Final Groundwater Monitoring Report

Amaknak Pre-WWII Tank Farm Formerly Used Defense Site

Unalaska, Alaska

APPENDIX H
Response to Comments

2-1

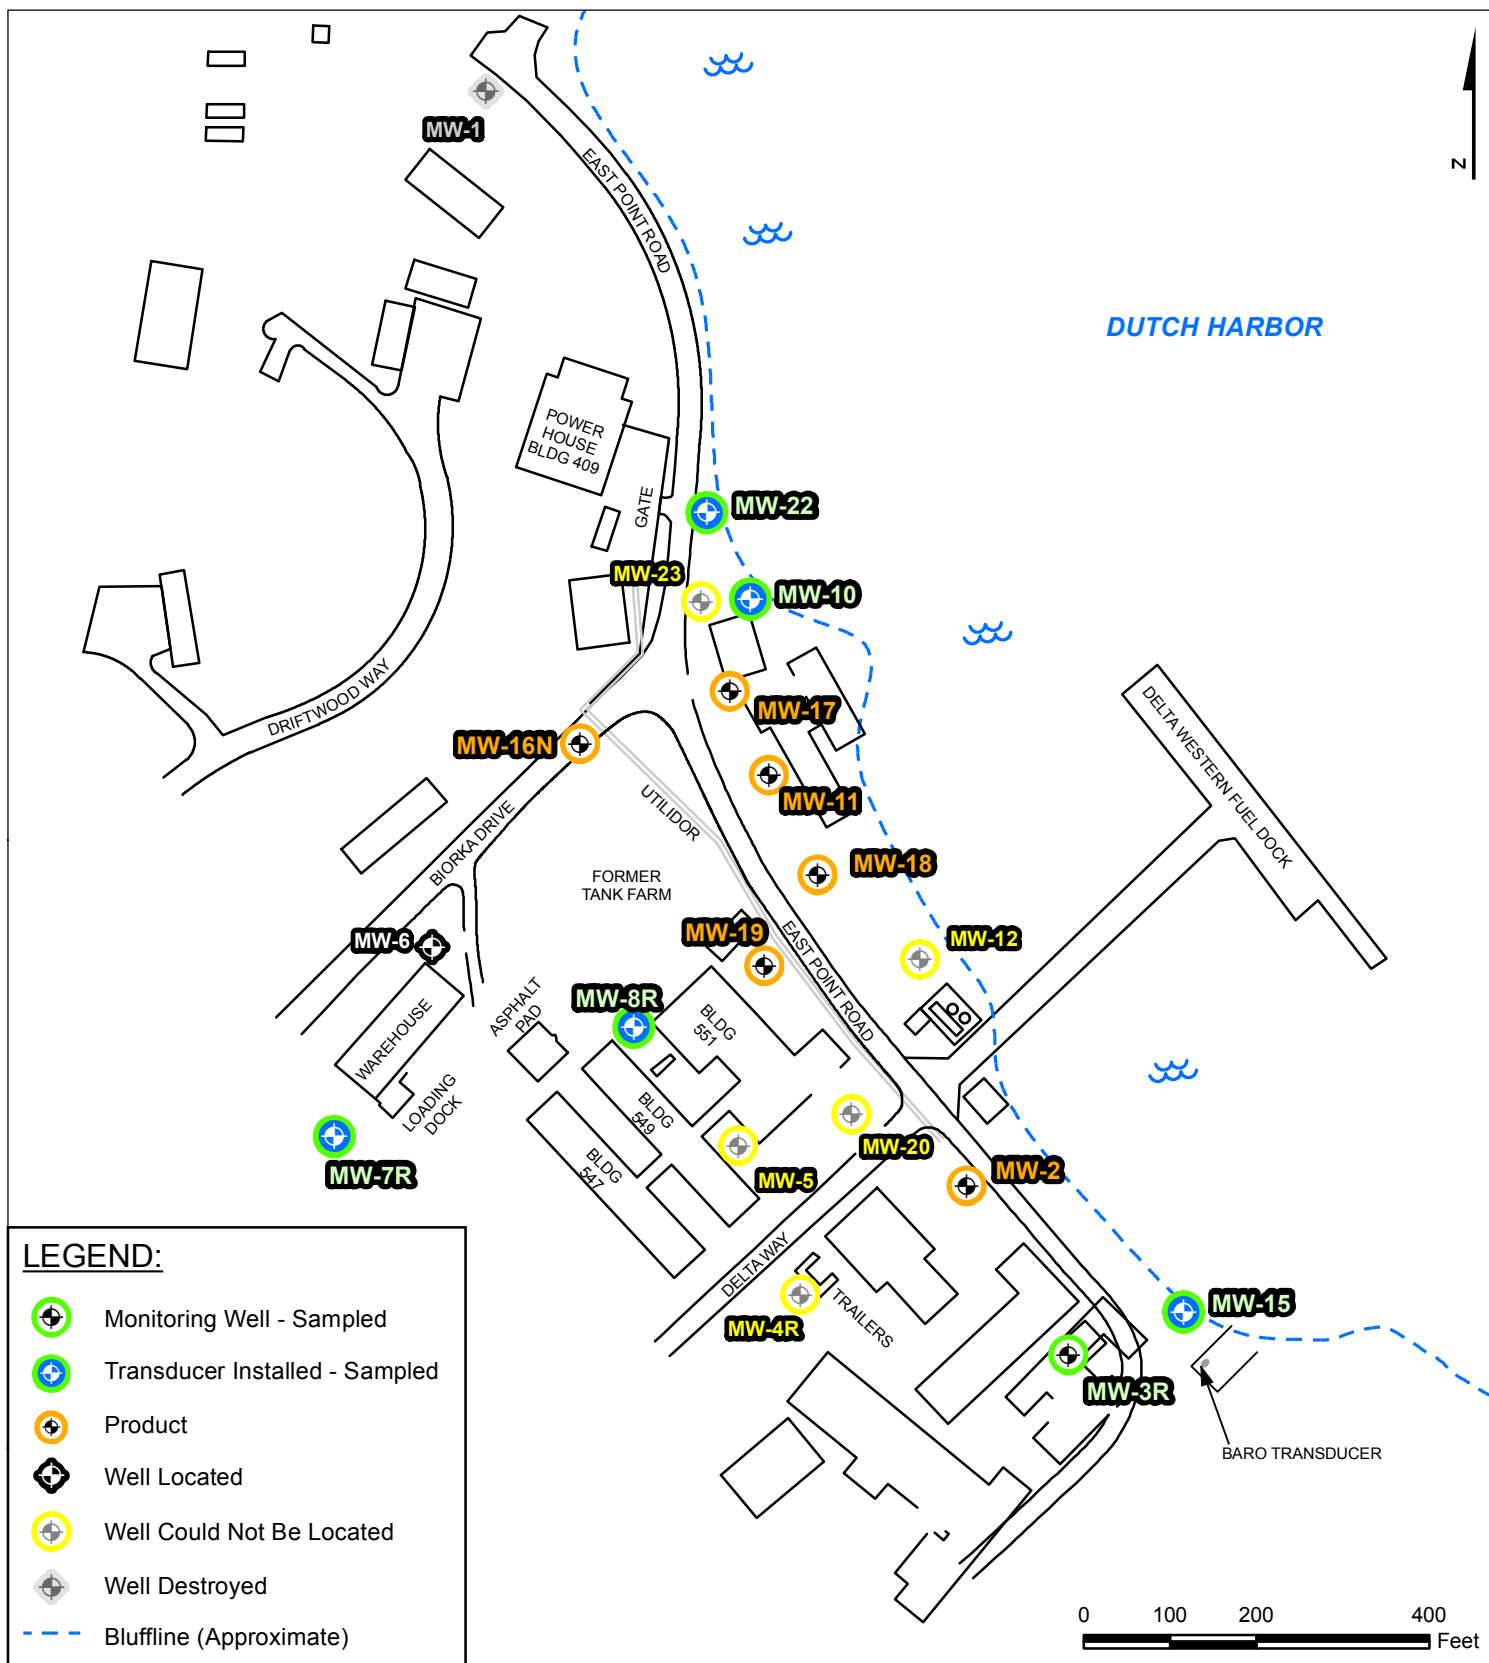
5.	Page 2-1, Table 2-1	MW-6 is listed in the table as being in good condition and in Figure 2-1 as decommissioned or destroyed. Groundwater elevation at W-6 is labeled on Figure 2-2. Please make consistent.	N	MW-6 was located, as indicated in both the figures and text. The symbol used for MW-6 in Figure 2-1 is described in the legend as "well located." The wells that were decommissioned or destroyed (such as MW-1) use a translucent grey (not black) symbol. The "well located" symbol will be altered to better differentiate it from the decommissioned/destroyed wells.	A
